Access Compliance Report

Public Rights-of-Way

Intersection ID: 15459	Main Street: CONISTON_PL	Cross Street: S_KINGS_DR	Location: NE
ADA ID: 70AFE264B5FA	Ramp Type: Directional1	Initial Pass/Fail: Fail	Overall Compliance: No
		Severity Score: 1.25

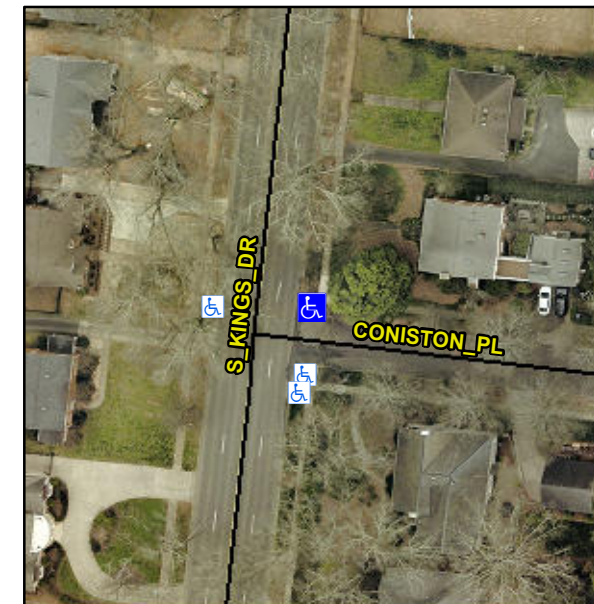
R304.5.3

Compliance	Description	Data	Compliance	Description	Data
N/A	Ramp Length (in)	84.0	N/A	Grade Break?	N/A
Yes	Ramp Width (in)	59.0	N/A	Grade Break Slope (%)	0.0
Yes	Ramp Slope (%)	7.6	N/A	Grade Break XSlope (%)	0.0
No	Ramp XSlope (%)	3.1			
N/A	Flare Type LT	N/A	N/A	Flare Type RT	N/A
N/A	Flare Slope LT (%)	N/A	N/A	Flare Slope RT (%)	0.0
N/A	Flare Traversable LT?	N/A	N/A	Flare Traversable RT?	N/A
N/A	Landing Length (in)	0.0	N/A	DWS Provided?	N/A
N/A	Landing Width (in)	0.0	N/A	DWS Contrast?	N/A
N/A	Landing Slope (%)	0.0	N/A	DWS Length (in)	N/A
N/A	Landing X Slope (%)	0.0	N/A	DWS Full Width?	N/A
N/A	Landing Curb? (Y/N)	N/A	N/A	DWS Offset LT (in)	N/A
N/A	Shared Landing?	N/A	N/A	DWS Offset RT (in)	N/A
N/A	Gutter Ponding?	0.0	N/A	Gutter Slope (%)	N/A
N/A	Gutter Lip Ht (in)	0.0	N/A	Gutter X Slope (%)	N/A
N/A	Painted X Walk1?	No		Road Slope (%)	4.6
	X Walk 1 Direction	To SE		Road X Slope (%)	2.0
	X Walk 1 Width (in)	N/A		Clear Space?	N/A

Remove & Replace Entire Ramp.
